REFERENCE LHC-TC-EC-0016

ENGINEERING CHANGE REQUEST

Installation of Low-Impedance Primary Collimators with BPMs (TCPPM) in IR7

Figure 1 — 3D view [5] of the TCPPM collimator (smarTeam code: ST0953409). Top: full collimator, with RF fingers. Bottom: sketch with left jaw only to show the 60 cm active length (obtained through blocks of different thickness).

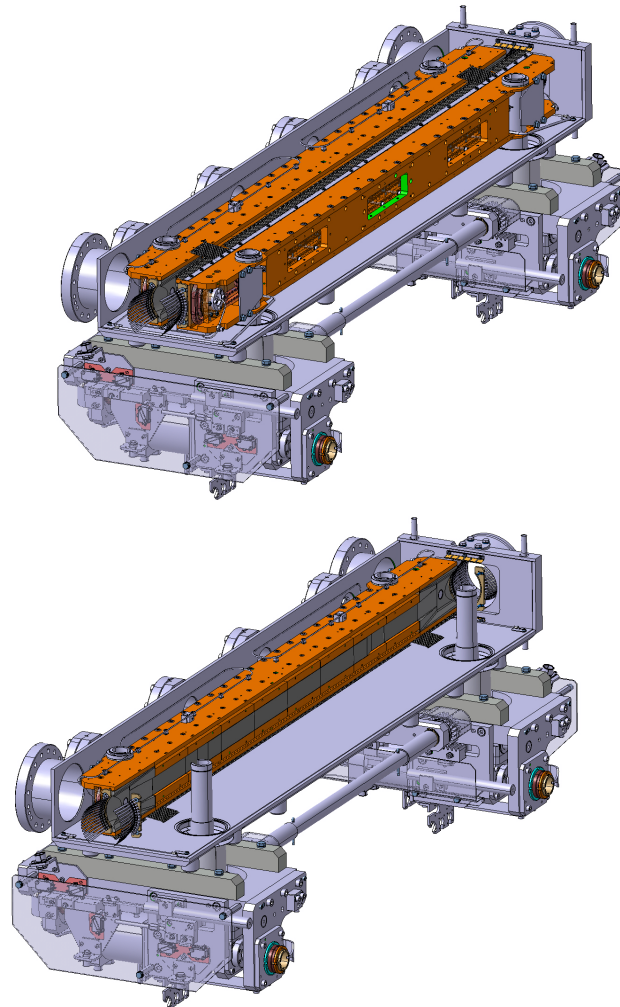
The present TCPPM design (see Figure 1) is similar to the one of the present TCPs [1]; among the most noticeable differences, there are the jaw material and the presence of Beam Position Monitors (BPMs). In fact, the design foresees jaws made of a composite material (MoGr) obtained from Molybdenum and graphite, chosen for its lower impedance and similar robustness with respect to the jaw material of the present TCPs (Carbon-Fiber-Composite, CFC). The new material is characterised by an impedance lower by about a factor 2 with respect to the one of CFC. The collimator jaws are equipped with BPM button pick-ups, for an easy determination of the beam closed orbit at the collimator and fast and precise alignment of the jaws. A third BPM is installed on the tank, to measure the beam position on the axis orthogonal to the one of cleaning.
